Re: Conditional Use and Conditional Building and Site Design Review Time Extension
Requests for the Red Rock Brewery Brewhouse at 426 West 400 North

RE: **Record of Decision for Petitions PLNPCM2018-01008 and PLNPCM2019-00255 Conditional Use and Conditional Building and Site Design Review (CBSDR) for the Red Rock "Brewhouse" – Brewery and Tasting Room**

Re: PLNPCM2018-01008 and PLNPCM2019-00255 Conditional Use and Conditional Building and Site Design Review for the Red Rock Brewhouse – Brewery and Tasting Room

C3 SOUTH ELEVATION RENDER
AE2-03 SCALE: NTS

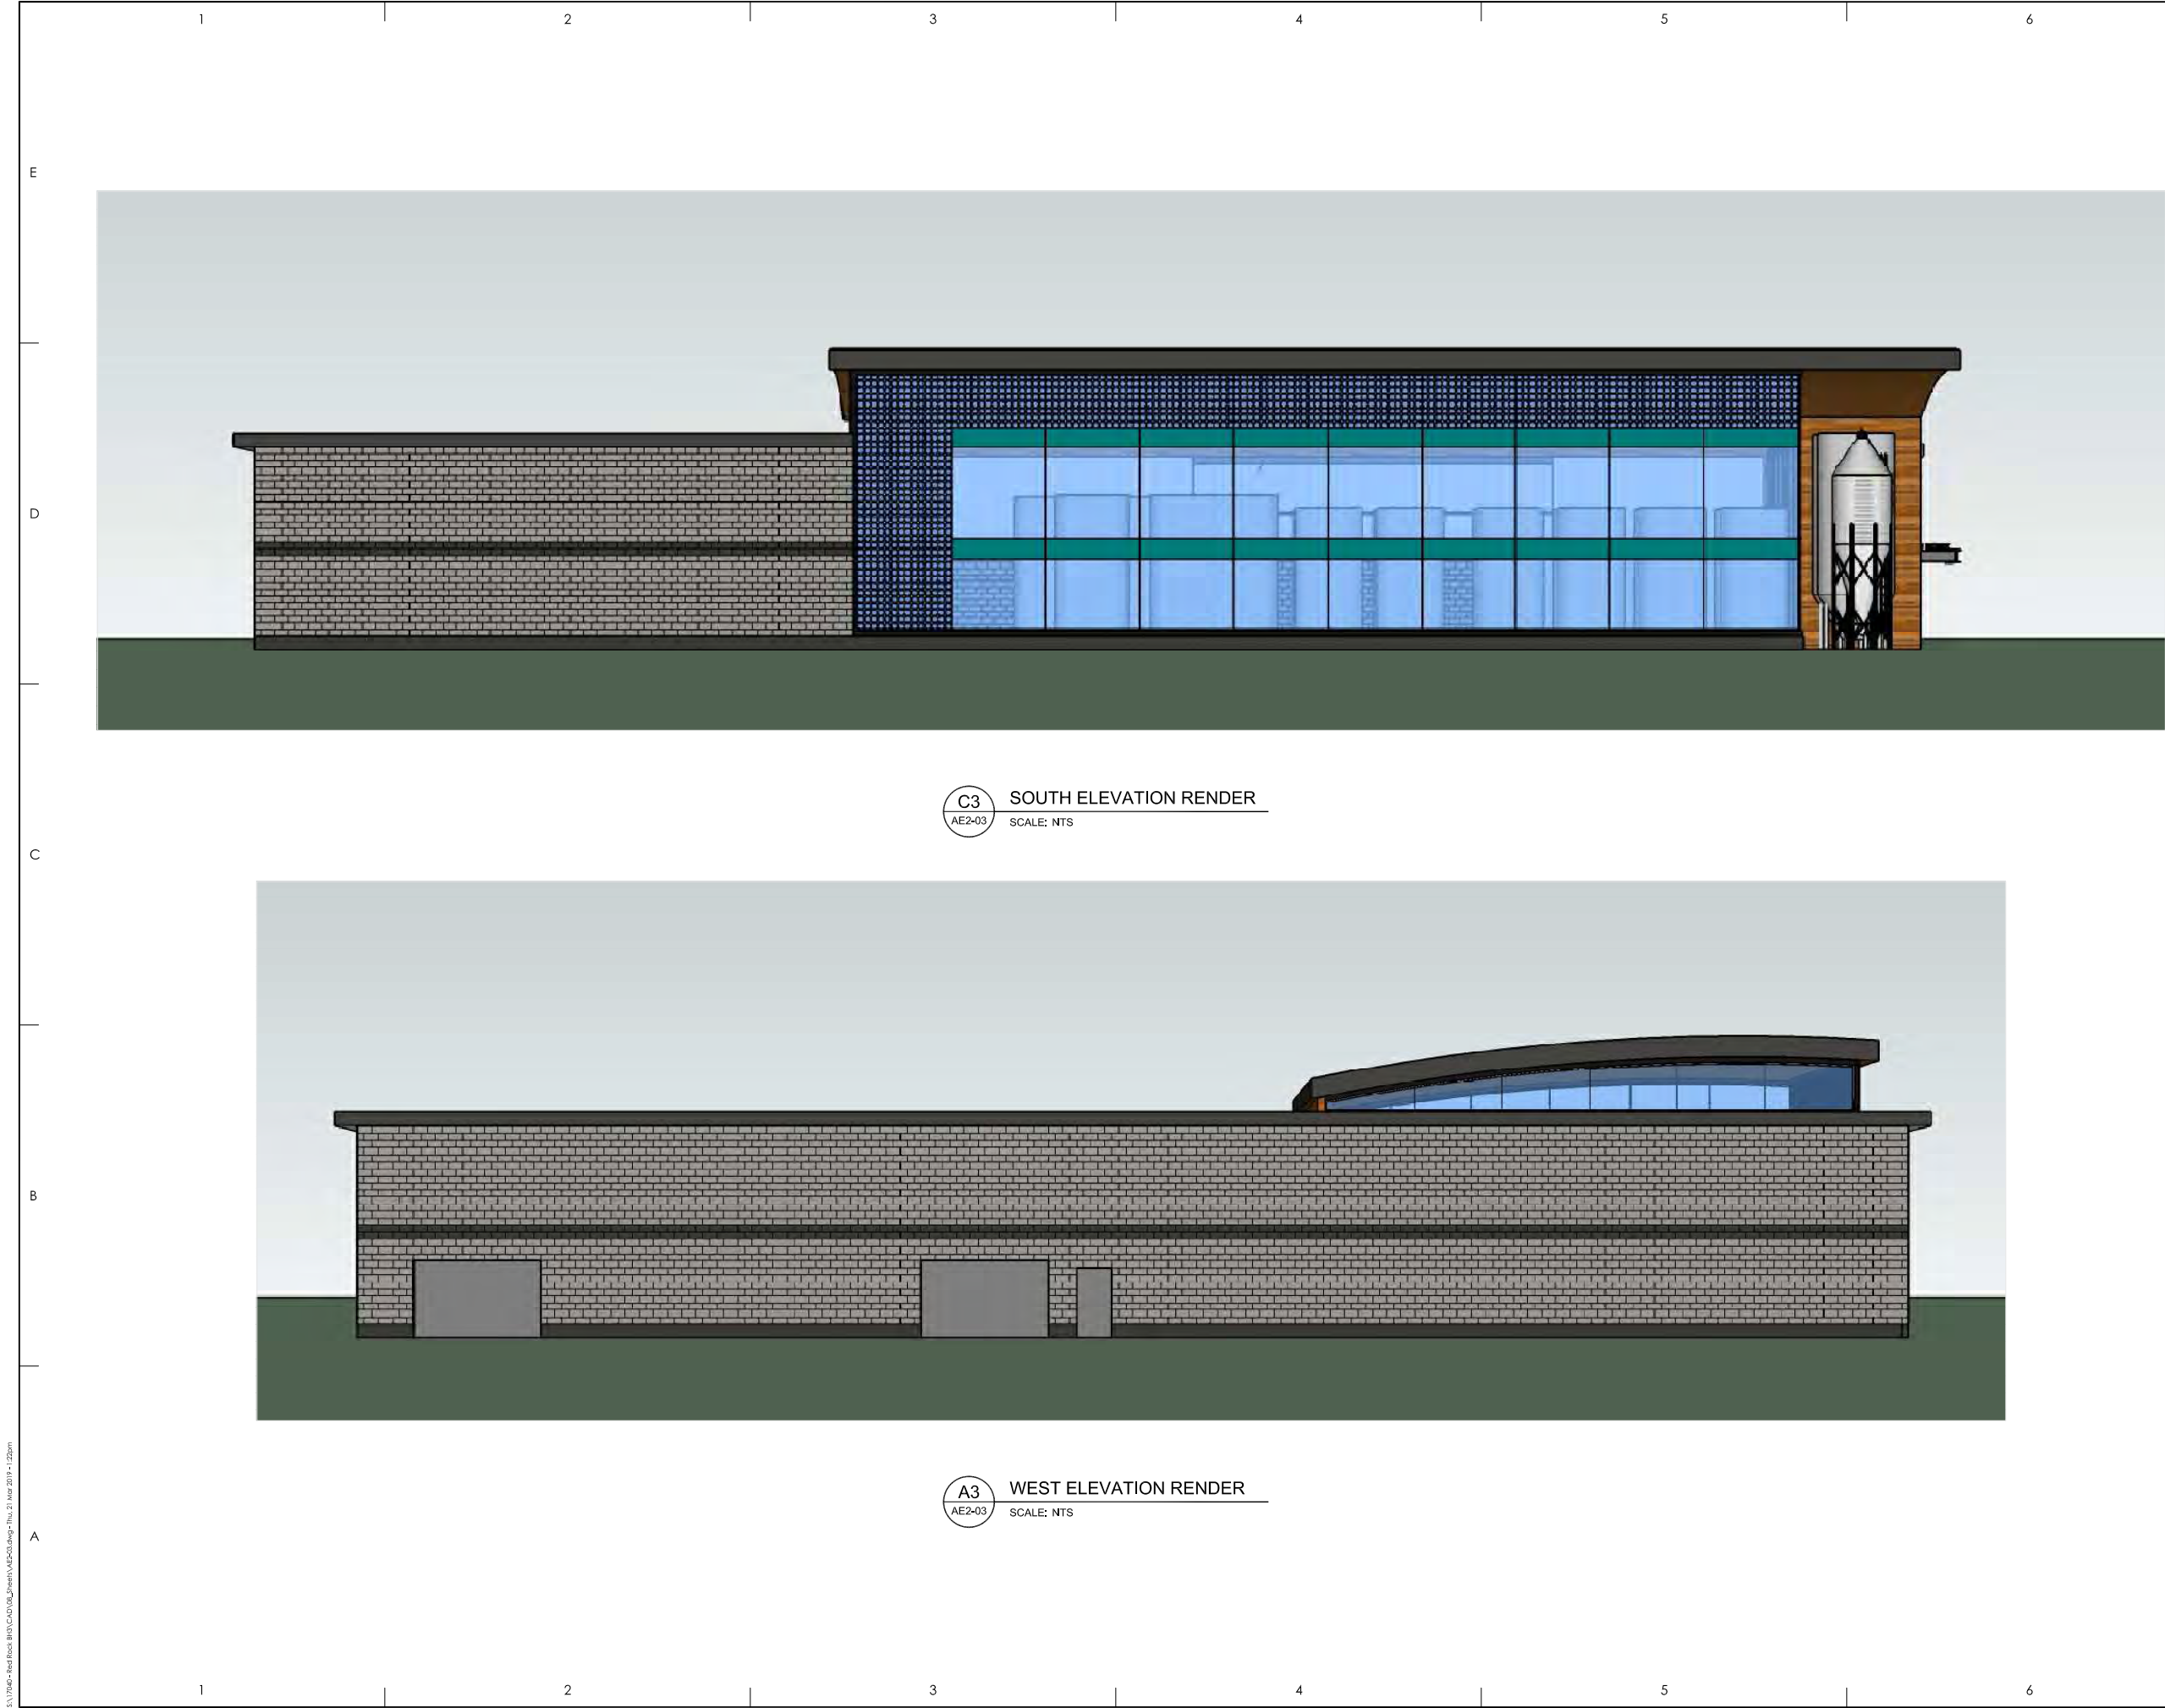
standard is to provide active building frontages that add interest, life, and vitality to the public realm. On the south and east facing street level façades, the proposed design incorporates walls that exceed that length. The south elevation includes a section of blank wall that measures approximately 55-feet 4-inches in length and the east elevation includes a blank wall section that is approximately 21-feet in length. The applicant has stated that this is a response to the internal functions and programming of the building. The addition of extra glass on the south elevation is intended to partly offset this. As outlined in consideration 2 above, they are proposing to incorporate approximately 1411 square feet of glass on the south elevation which is well in excess of the required 508 square feet. The location of this however is part of the CBSDR modifications requested. **The applicant's narrative also** describes the material changes in terms of the brewery and brewery support functions and that additional windows may be added to the second level as offices once the building programming has been finalized. The blank wall and glass requirements pertain to the ground floor level so the addition of glass to the second floor level is not germane to meeting the regulations and cannot be guaranteed by Planning Staff nor is it something that would meet the Design Standards.

Planning Staff acknowledges the programming needs of the building as a consideration in regard to the requested modification to allow for larger blank wall spaces on the south elevation but has concerns about how this elevation will impact the pedestrian experience and street interaction due to the lack of detailing on the south facade. Planning Staff is recommending that the Planning Commission approve this modification to allow for a longer blank wall but require that the applicant integrate some kind of artwork, mural or other element of visual interest along that elevation in order to break up the blank wall space. Staff is including this as a condition of approval.

1. *Artwork, a mural or other element of visual interest along the south elevation is required in order to break up the blank wall space and provide the appearance of activity.*
2. *One additional doorway must be located along the south elevation in order to break up the blank wall space.*
3. *Final approval of landscaping, signage, lighting and the visual addition on the south façade is delegated to Planning Staff to ensure compliance with applicable standards.*
4. *Any modifications to the approved plans after the issuance of a building permit must be specifically requested by the applicant and approved by the Planning Division prior to execution.*
5. *Applicant shall comply with all other department/division requirements.*

South Elevation Required per 21A.37.060

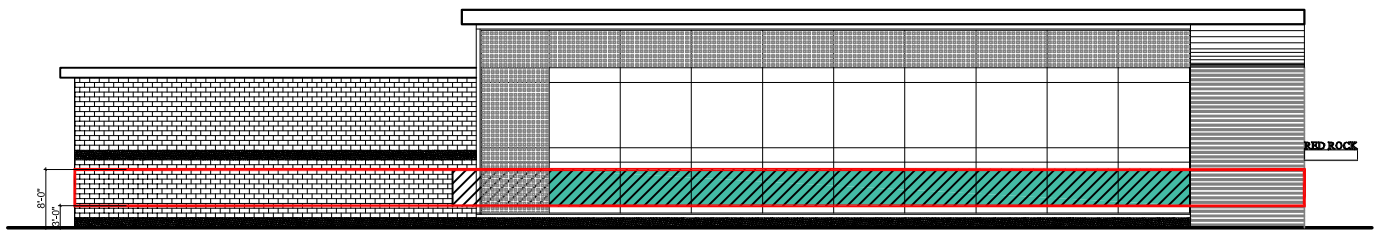
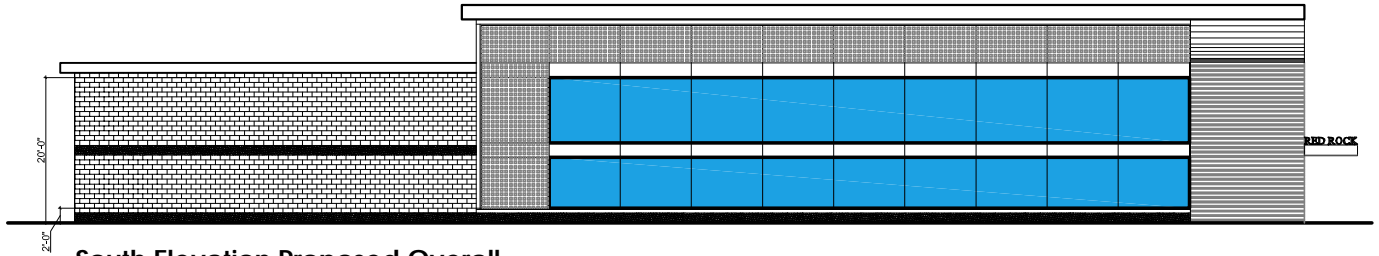
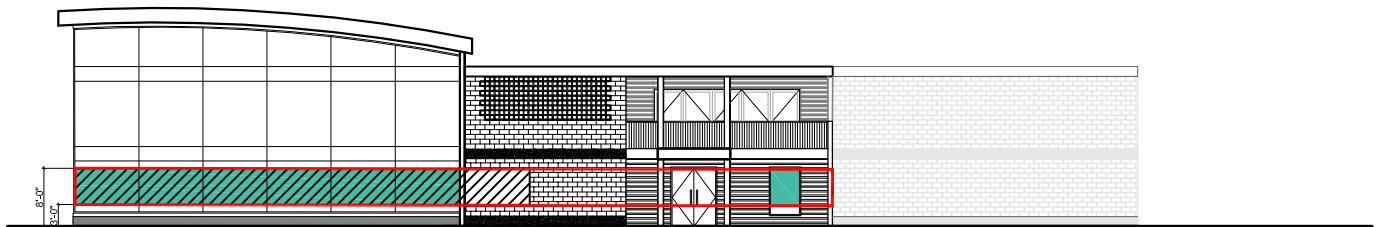
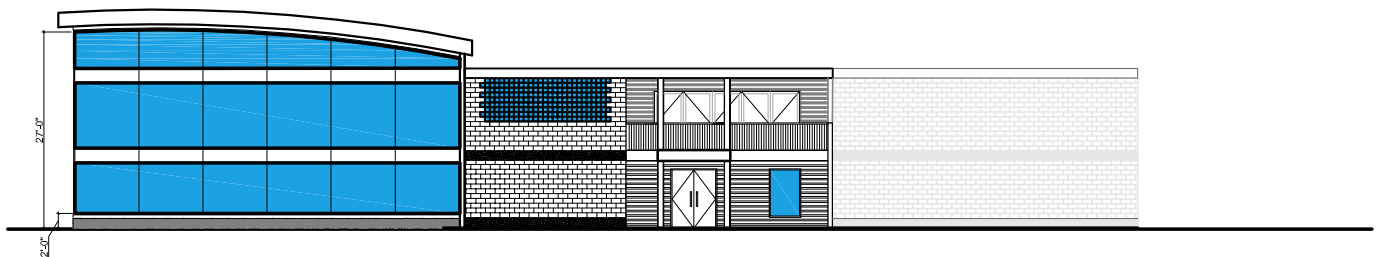
The ground floor glass requirements per Chapter 21A.37 – Design Standards specify that the street-facing facades must incorporate 60% glass in the area from three (3) to five (5) feet above grade. On the south-facing elevation toward 400 North, this would equate to approximately 508 square feet of glass being required within that zone.

The applicant's design concentrates the glass on the east side of the south façade, in between two (2) and twenty (20) feet above grade. As a result, they are proposing to provide approximately 1411 square feet of total glass area on that elevation, but only 441 square feet within the required 2 to 8 foot area above ground level.

On the east-facing elevation toward 400 W, the required glass between 3 and 8 feet is approximately 313 square feet. The applicant has proposed to incorporate a total of 1100 square feet of glass on that elevation, but only 285 square feet within the required area. The provided glass would be located between 2 and 27 feet above grade and is concentrated toward the south side and the corner of 400 N and 400 W. The requirements specify between 3 and 8 feet but the design put forth by the applicant extends lower (to 2 feet) and much higher (27 feet) above grade.

Planning Staff is recommending that the Planning Commission approve this modification to the glass requirements as the development is exceeding the overall area of glass required and using it to create a pedestrian focal point toward the corner of the building.
